REVIEW OF PLANS AND SPECIFICATIONS

WYOMING DEPARTMENT OF ENVIRONMENTAL QUALITY
WATER QUALITY DIVISION
State Office Building
Cheyenne, Wyoming 82002

PROJECT: City of Riverton, Wells No. 15 & 16, Riverton, Wyoming

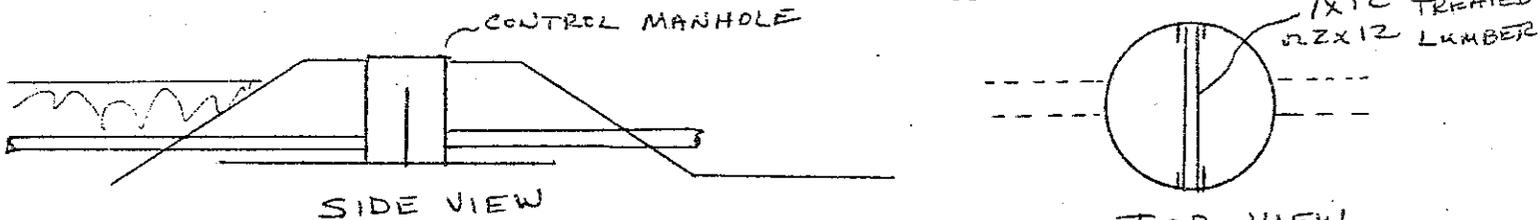
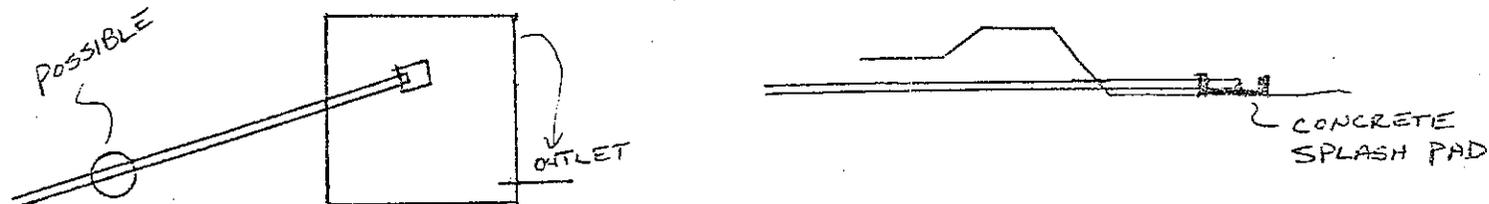
The manholes located at B-B and C-C do not have any method of lagoon water surface level control. Below is a recommended method. Section D-D is the most critical and definitely should have this type of flow control.

The outfall manhole preceding the lagoon is not required on a force main. The force main should terminate as close to the center of lagoon as possible to keep a sludge bank from building up at the dike. This would also prevent freezing as the manhole shown on the drawing is very close to the surface. If a maintenance manhole is required on the force main, it should be located somewhere between the lagoon and the lift station.
